STATE HIGHWAY 105 / JACKSON CREEK PARKWAY - PHASE 2

CONSTRUCTION PLANS

Comments provided by DPW Development Services

Comments provided by DPW Capital Projects

EL PASO COUNTY SIGNING AND STRIPING NOTES:

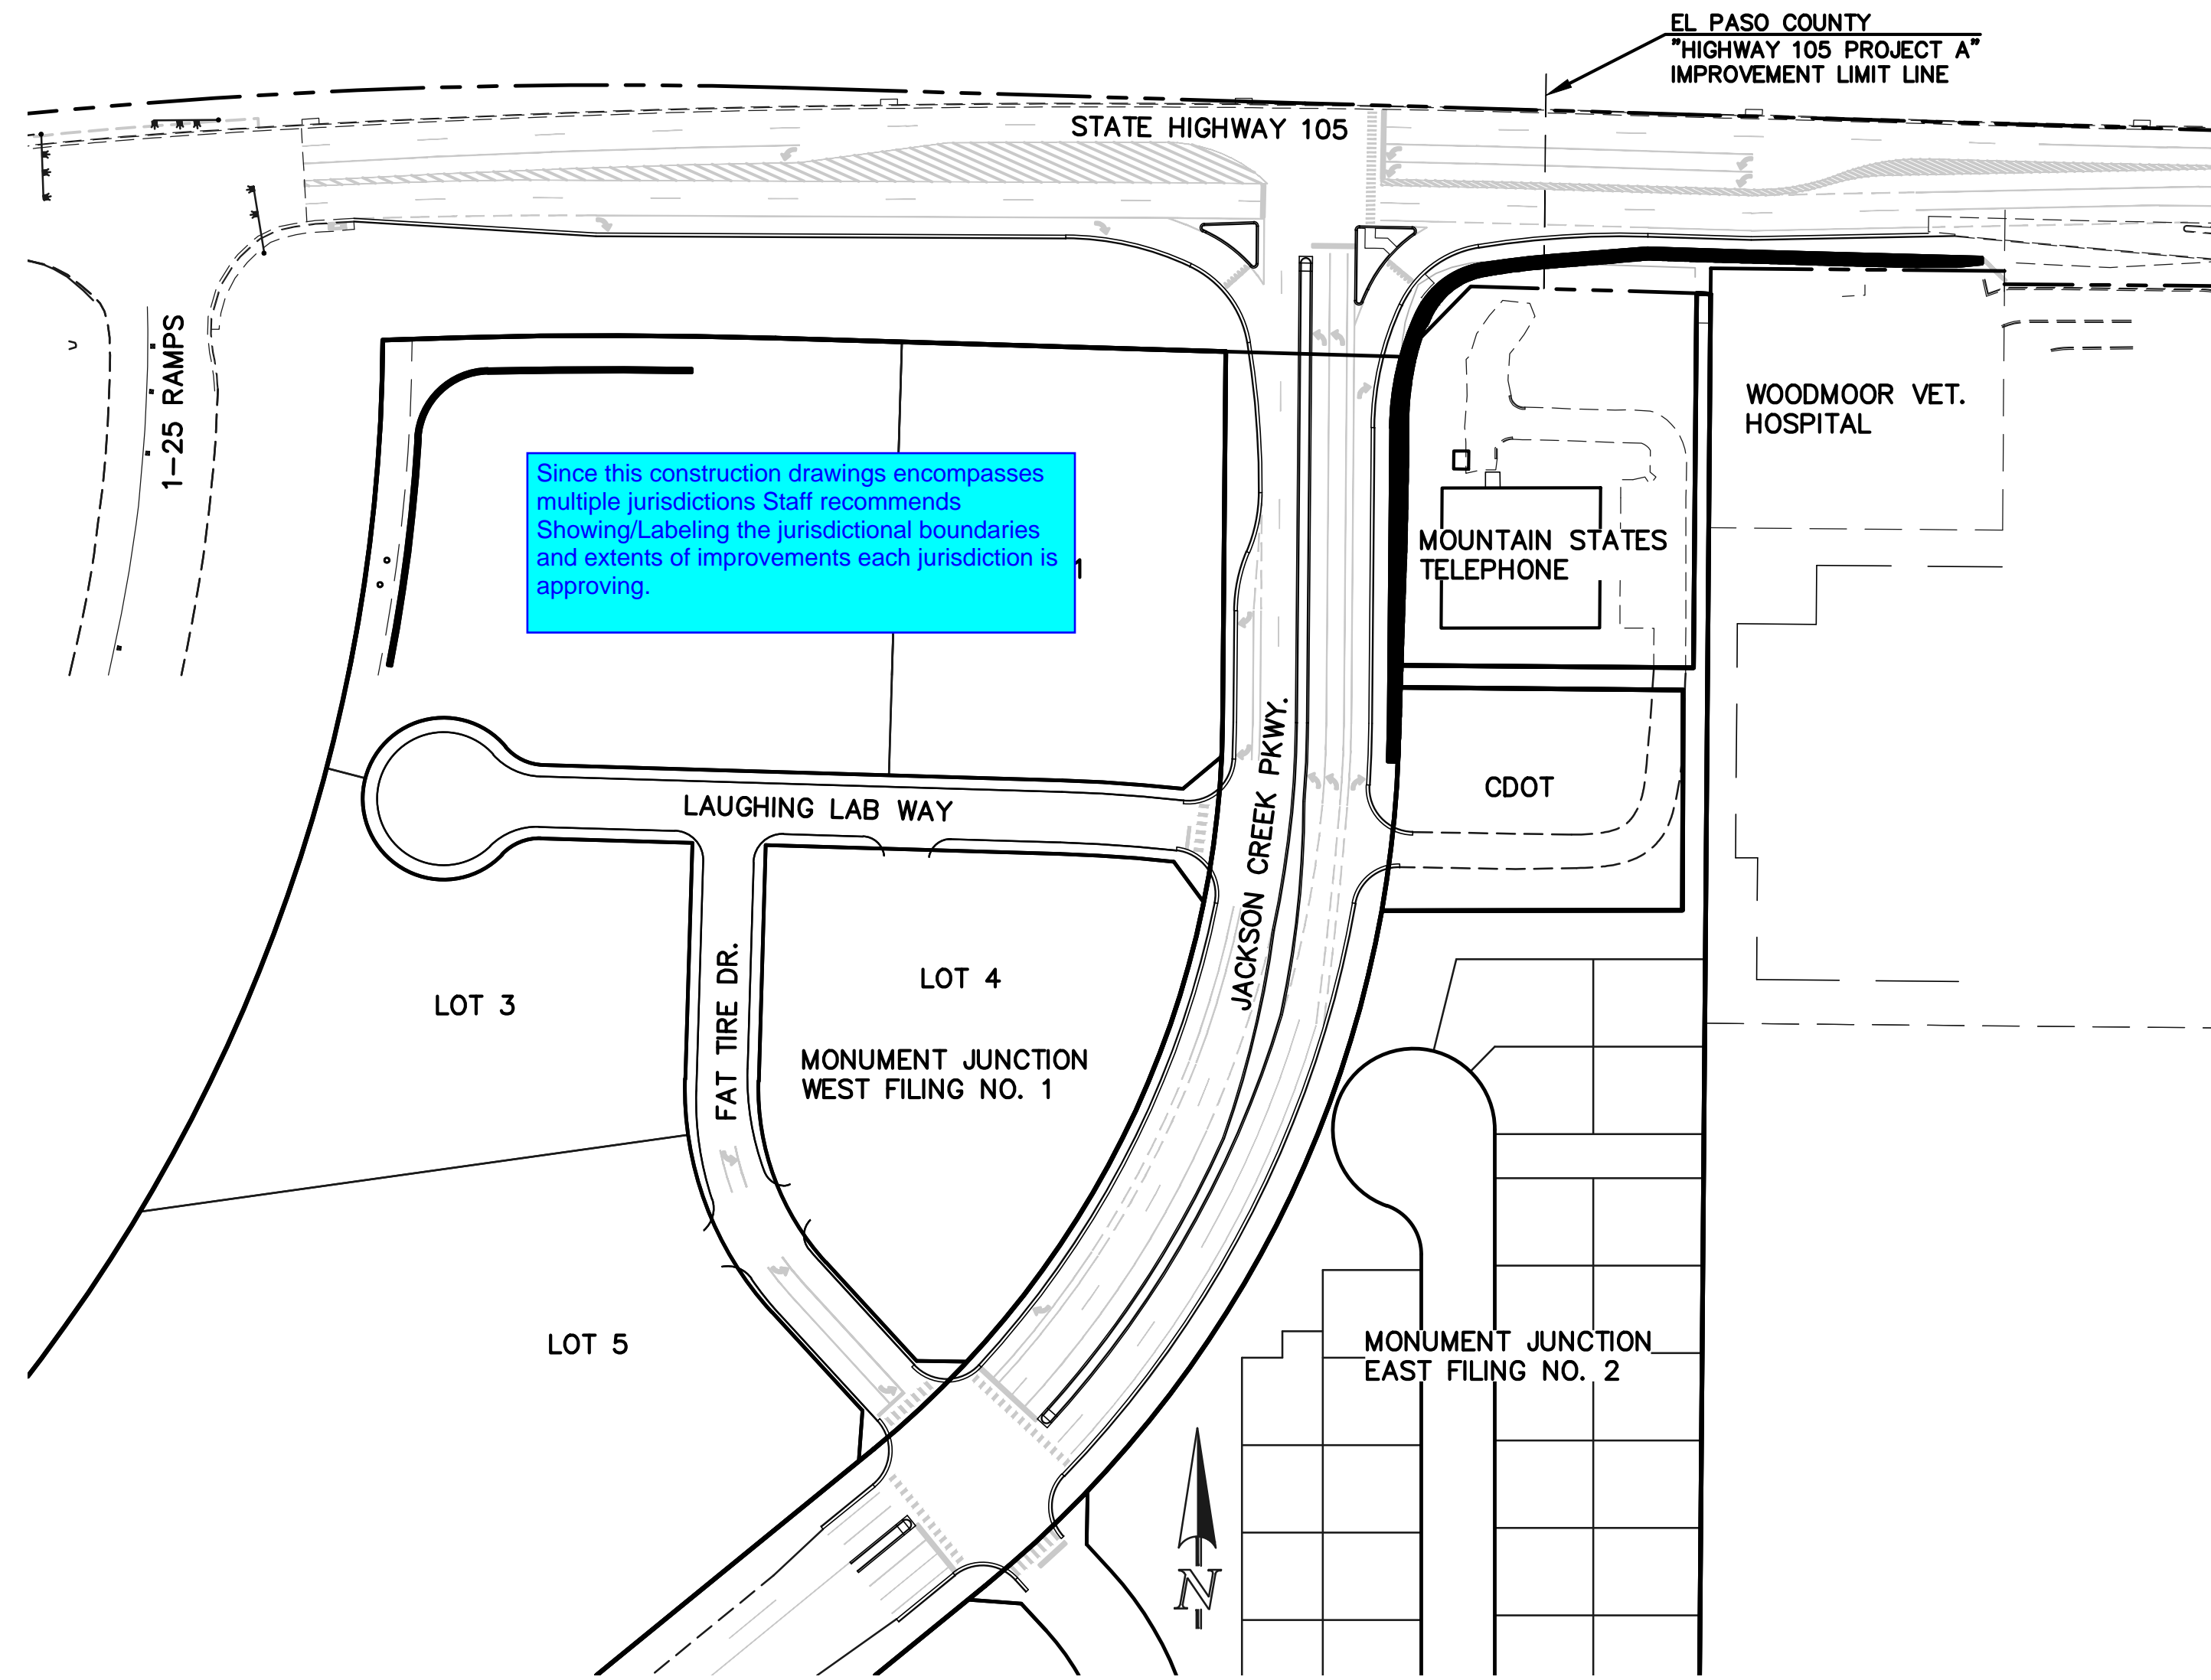
Change dimensions to 24" & 8' Reference reference to CDOT detail.

STATE HIGHWAY 105 / JACKSON CREEK PKWY. - PHASE 2 CONSTRUCTION PLANS			
ROADWAY IMPROVEMENTS PLANS			
GRADING & EROSION CONTROL PLAN			
DESIGNED BY	PRA	SCALE	DATE 02-23-23
DRAWN BY	PRA	(H) 1" = 50'	SHEET 5 OF 23
CHECKED BY	(V) 1" = 5'	JOB NO.	1302.22

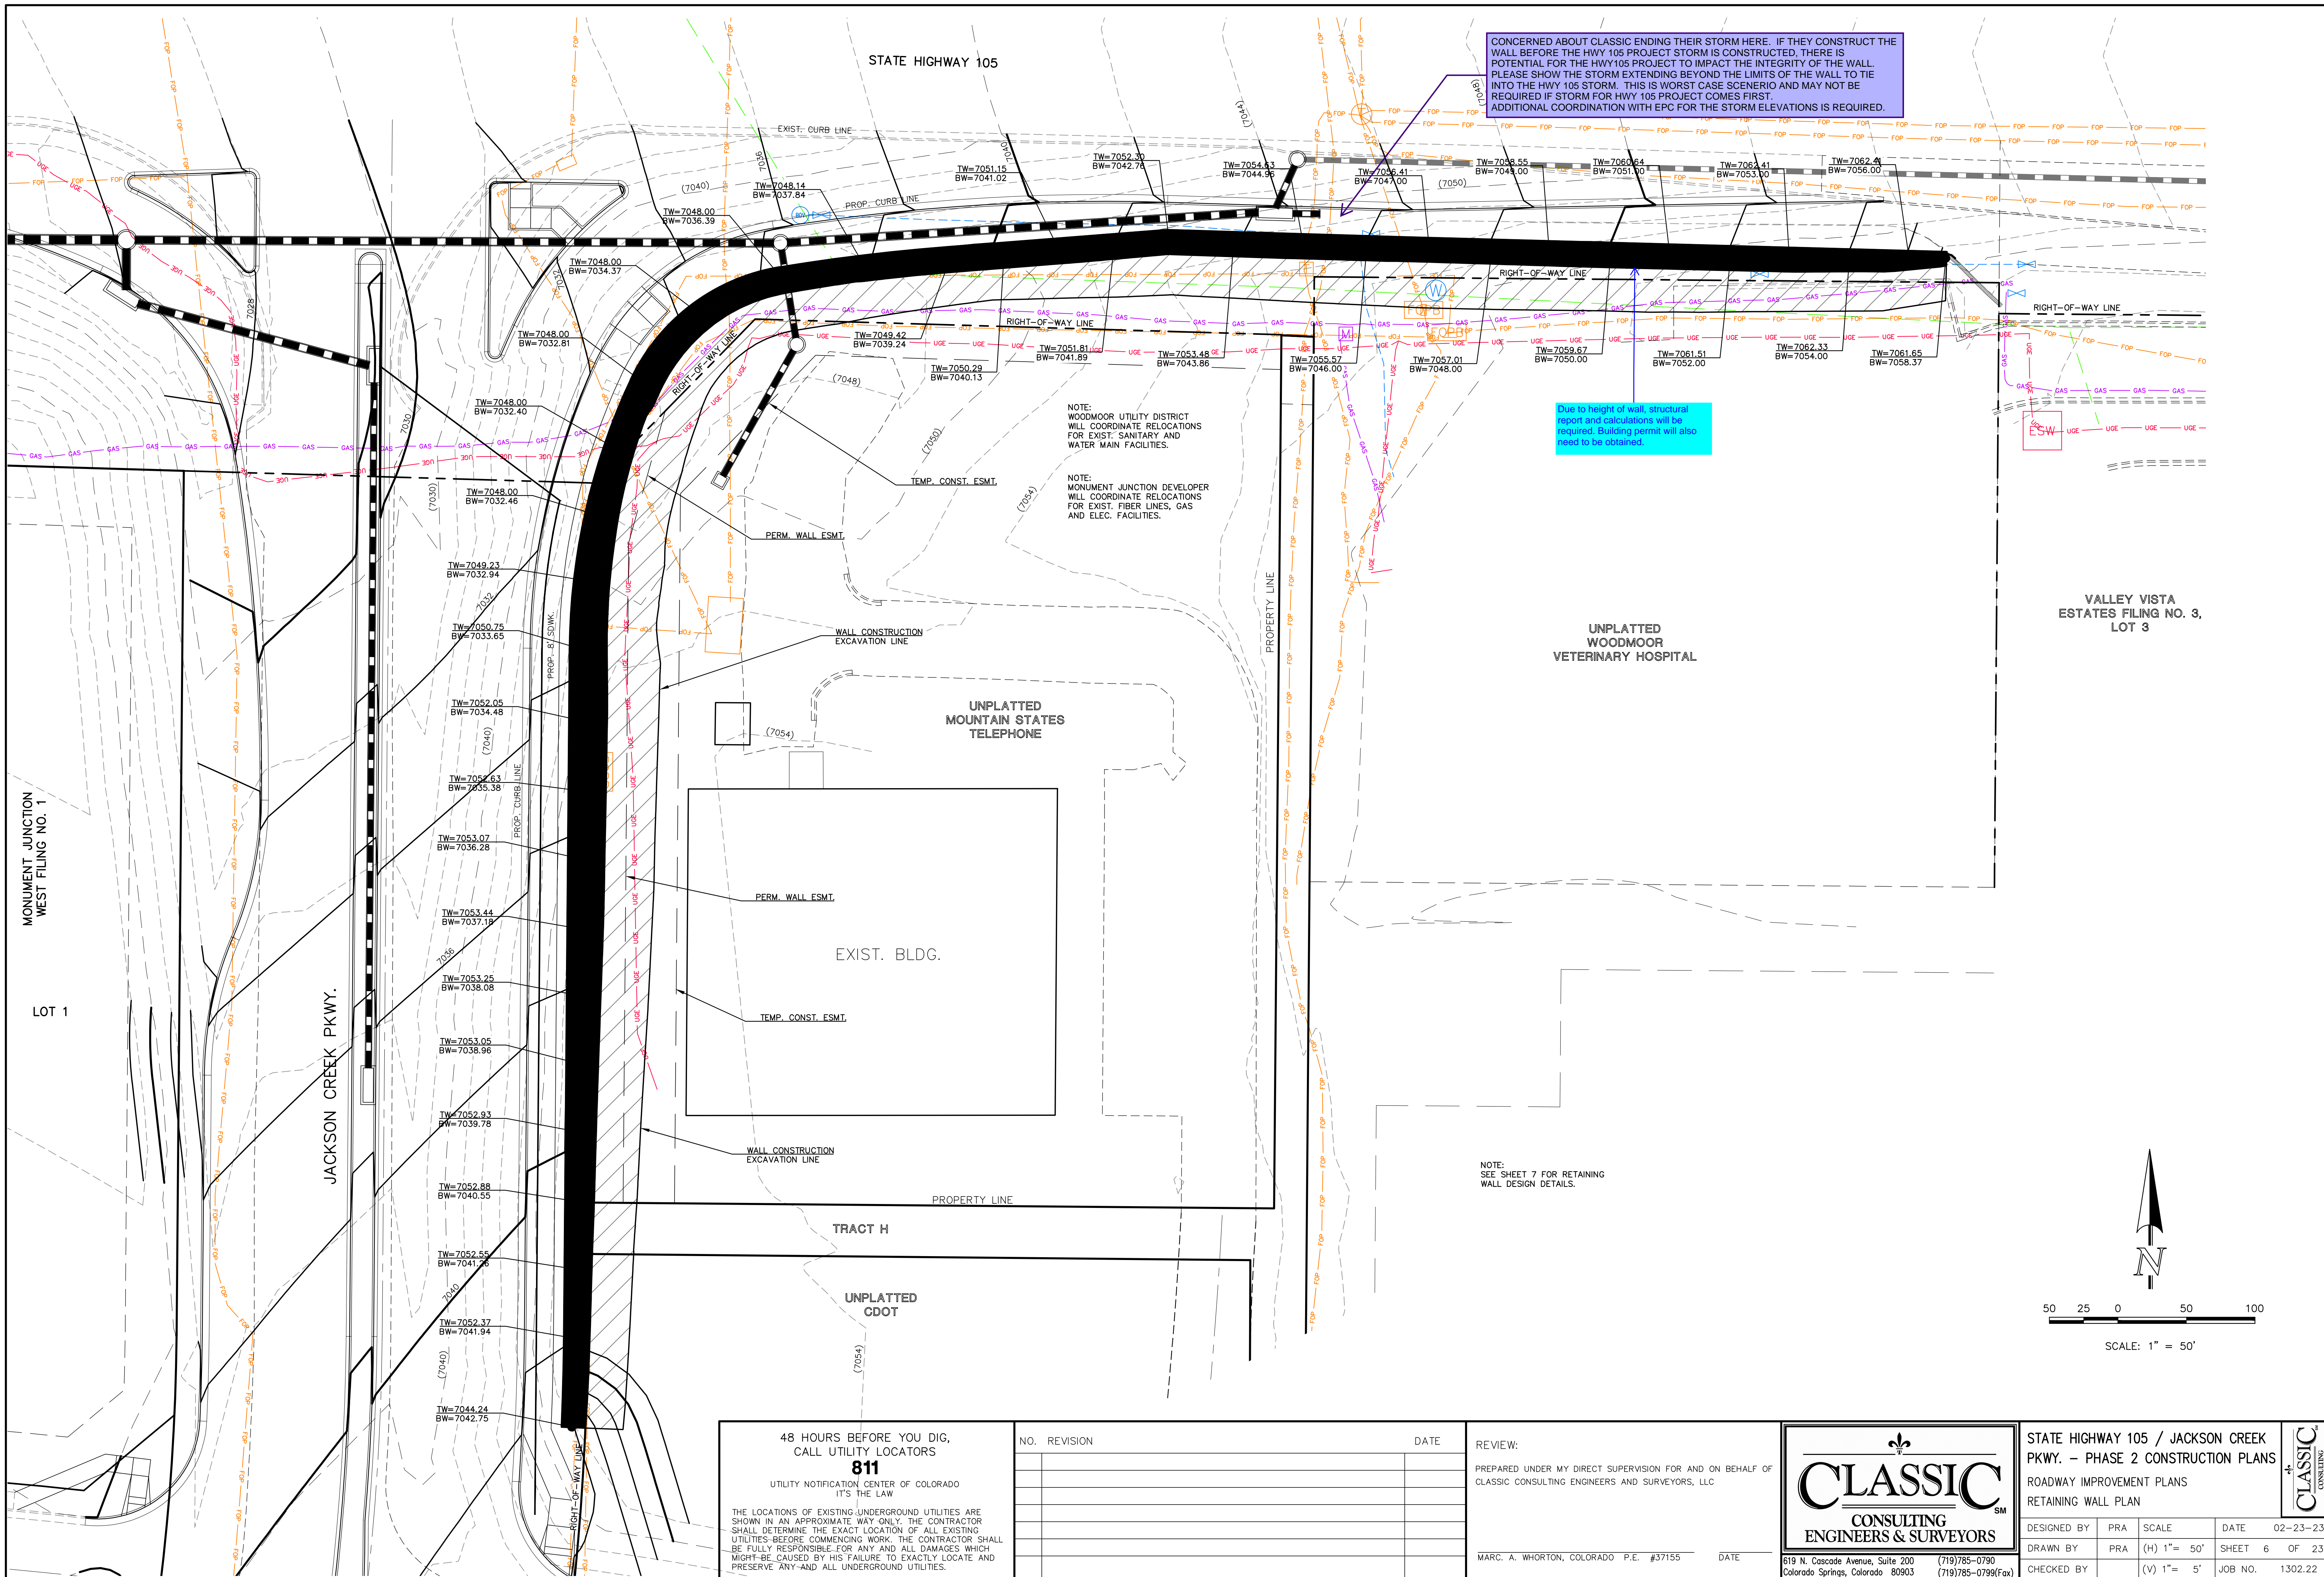
CONCERNED ABOUT CLASSIC ENDING THEIR STORM HERE. IF THEY CONSTRUCT THE WALL BEFORE THE HWY 105 PROJECT STORM IS CONSTRUCTED, THERE IS POTENTIAL FOR THE HWY 105 PROJECT TO IMPACT THE INTEGRITY OF THE WALL. PLEASE SHOW THE STORM EXTENDING BEYOND THE LIMITS OF THE WALL TO TIE INTO THE HWY 105 STORM. THIS IS WORST CASE SCENARIO AND MAY NOT BE REQUIRED IF STORM FOR HWY 105 PROJECT COMES FIRST. ADDITIONAL COORDINATION WITH EPC FOR THE STORM ELEVATIONS IS REQUIRED.
